ARCHITECTURAL REVIEW BOARD MEETING
CITY HALL, 385 SOUTH GOLIAD STREET, ROCKWALL, TEXAS
JULY 28, 2026 IN THE CITY COUNCIL CONFERENCE ROOM AT 5:00 PM

PROJECT COMMENTS

PROJECT NUMBER: SP2026-014
PROJECT NAME: Site Plan for 5133 S FM 549
SITE ADDRESS/LOCATIONS: 5133 South Farm to Market 549, Rockwall, TX, 75032

PLANNING AND ZONING COMMISSION MEMORANDUM

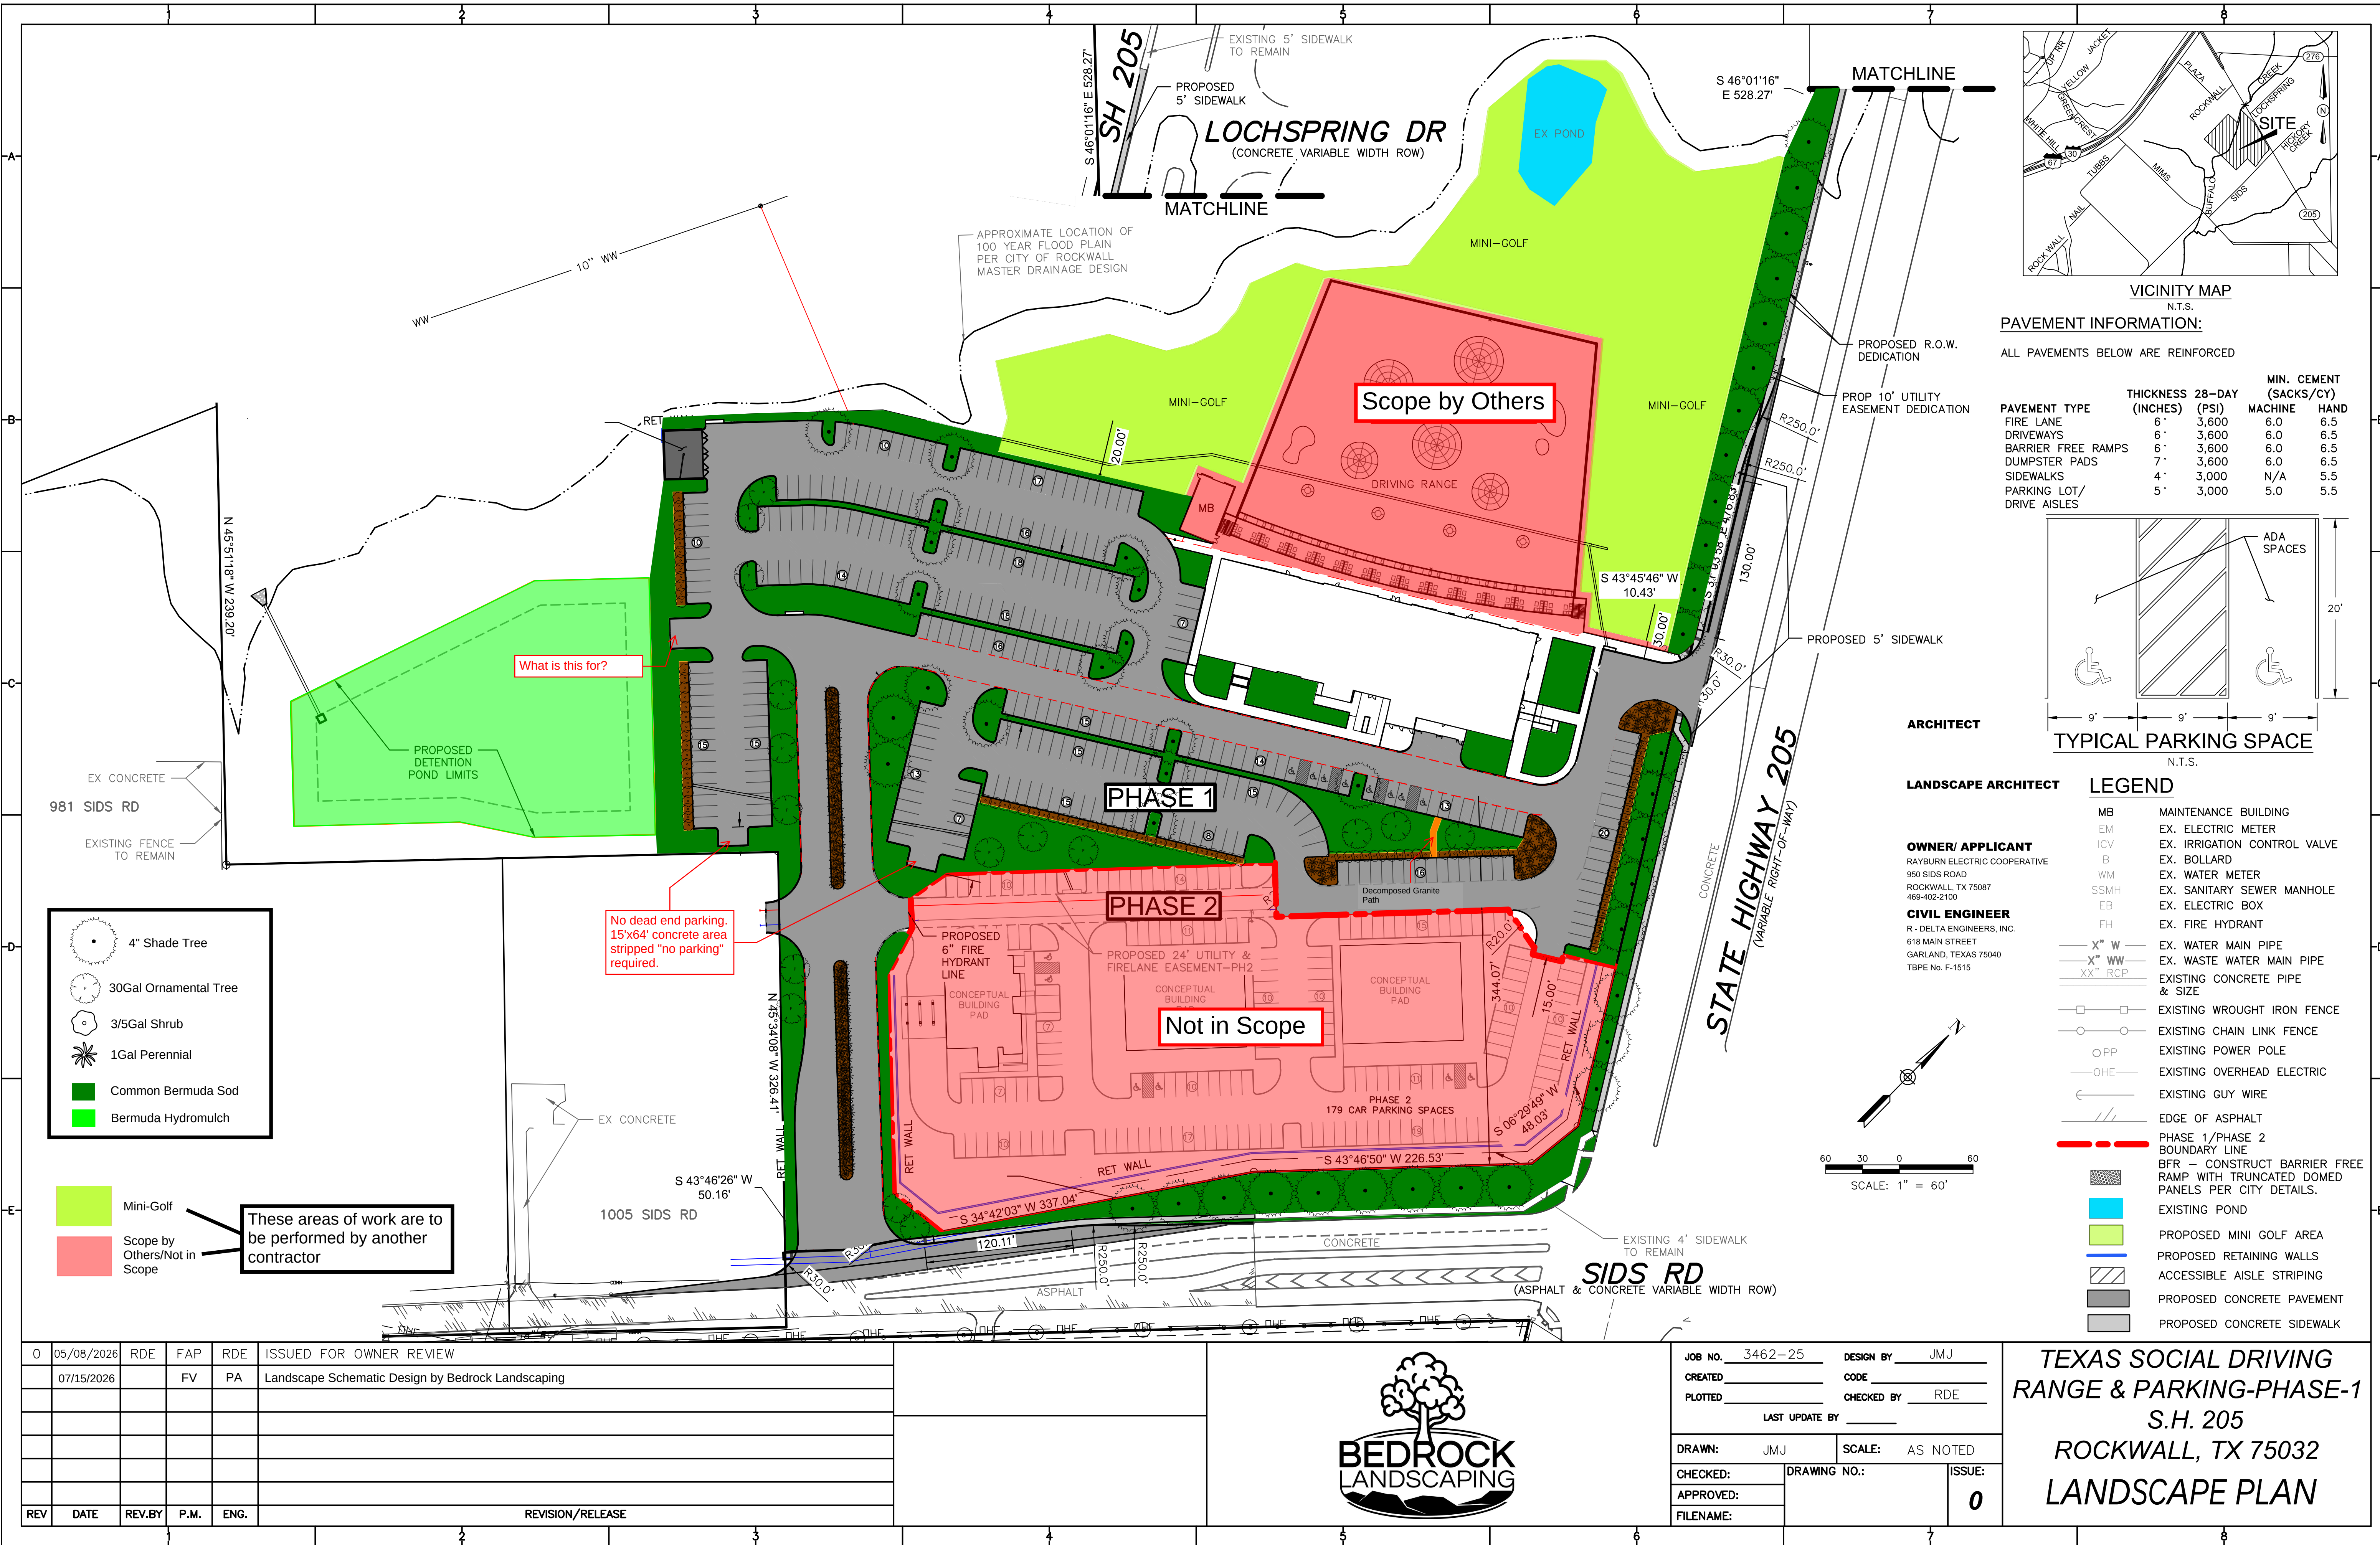
(1) Please remove the improvements and buildings associated with Phase 2. This area can be labeled as Phase 2, but we cannot have any improvements shown in this area. (Subsection 03.04. B, of Article 11, UDC)

- (2) Please provide the dimensions for the primary building. (Subsection 03.04. B, of Article 11, UDC)
- (3) Please delineate and label the building setbacks. The building setback along S. Goliad Street is 25-feet and the building setback along Sids Road is 15-feet. (Subsection 03.04. B, of Article 11, UDC)

- (4) Please indicate the dimensions of a standard parking space. (Subsection 05.03, of Article 06, UDC)
- (5) Please clarify if the parking for the maintenance/smoker building is included in the provided calculations. In addition, any outdoor seating requires one (1) parking space per four (4) seats. Please include this in the provided parking table. (Subsection 05.04, of Article 06, UDC)

- (9) Please provide a detail of the dumpster enclosure that meets the requirements of the UDC. (Subsection 01.05. B, of Article 05, UDC)
- (10) In the Commercial (C) District Outside Storage is not permitted. In this case, the smokers would be considered Outside Storage. Based on this, the smokers will need to be incorporated into the building. (Subsection 02.03, of Article 04, UDC)

- (11) Please clarify if there is a bay/roll up door for the loading area. If so, the appropriate screening will be required. (Subsection 01.05. A, of Article 05, UDC)

- (12) Any new or existing overhead power lines will need to be underground. (Subsection 03.03, of Article 04, UDC)
- (13) The subject property has residential adjacency with the Flagstone Subdivision to the west and the agriculturally zoned property to the south. This will require an exception from the Planning and Zoning Commission.

- (14) Please specify what the "Other/Future Family & Kid Friendly Amenities" are. If these are to be done at a later date, please remove the callouts from the plans at this time. (Subsection 03.03, of Article 04, UDC)
